RICHMOND AMERICAN HOMES JOB#28520046

PLOT PLAN LOT 23

SUBDIVISION: SPRINGS AT WATERVIEW FILING NO.1

Site Plan Drawing_V1.pdf Markup Summary

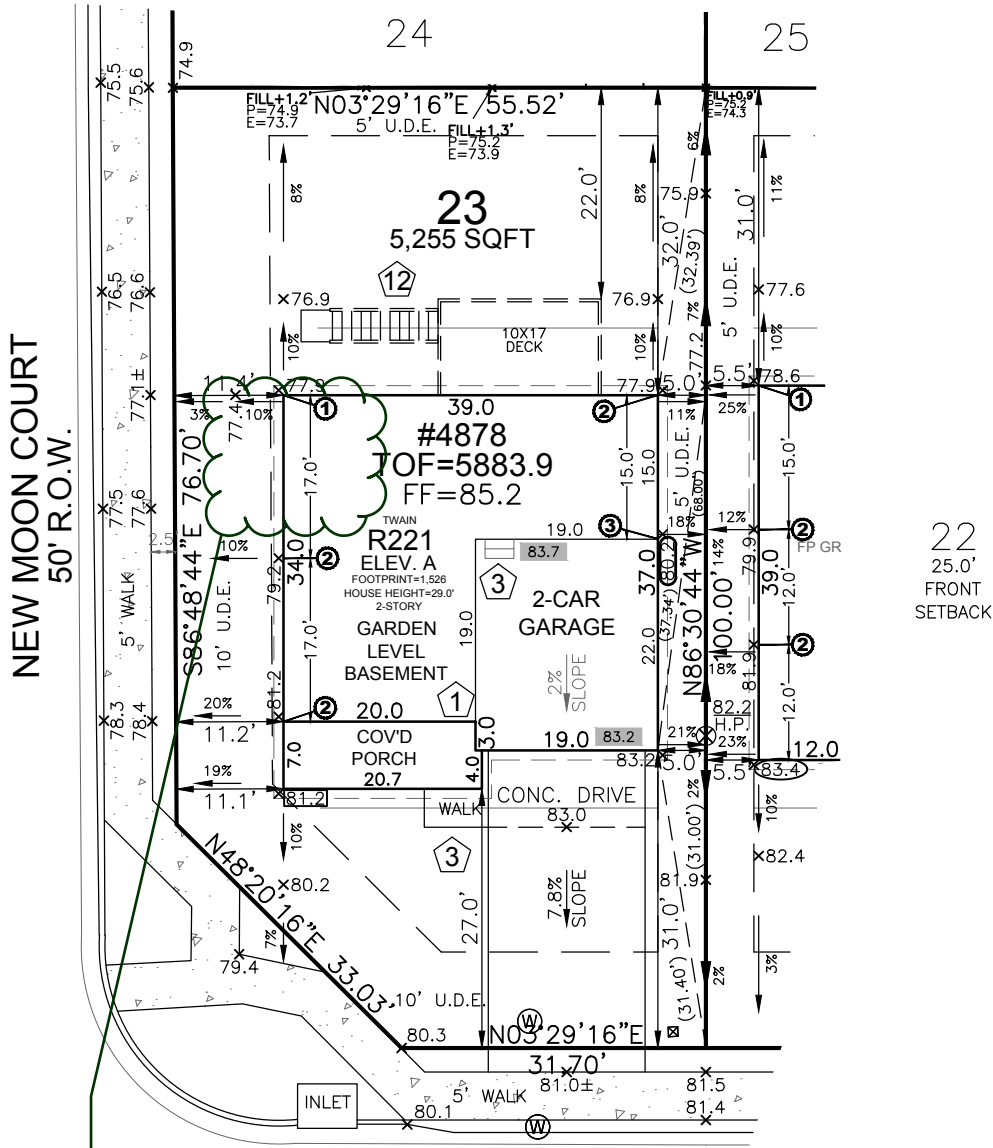
Proposed setback is not within **WOLF MOON DRIVE** 50' R.O.W. 20% of required setback of 15 feet to qualify for Admin. Relief. The required setback on the second front yard on a corner lot is 1/2 of the required front yard or 15 feet, whichever is greater. 15 feet is greater than 12.5 feet, or half of the front yard required. Therefore, the reduction can only be requested up to 12 feet (80% of the 15 feet required)

WATER METER IS IN DRIVEWAY; WILL NEED TO BE RELOCATED.

Proposed setback is not within 20% of required setback of 15 feet to qualify for Admin. Relief. The required setback on the second front yard on a corner lot is 1/2 of the required front yard or 15 feet, whichever is greater. 15 feet is greater than 12.5 feet, or half of the front yard required. Therefore, the reduction can only be requested up to 12 feet (80% of the 15 feet required)
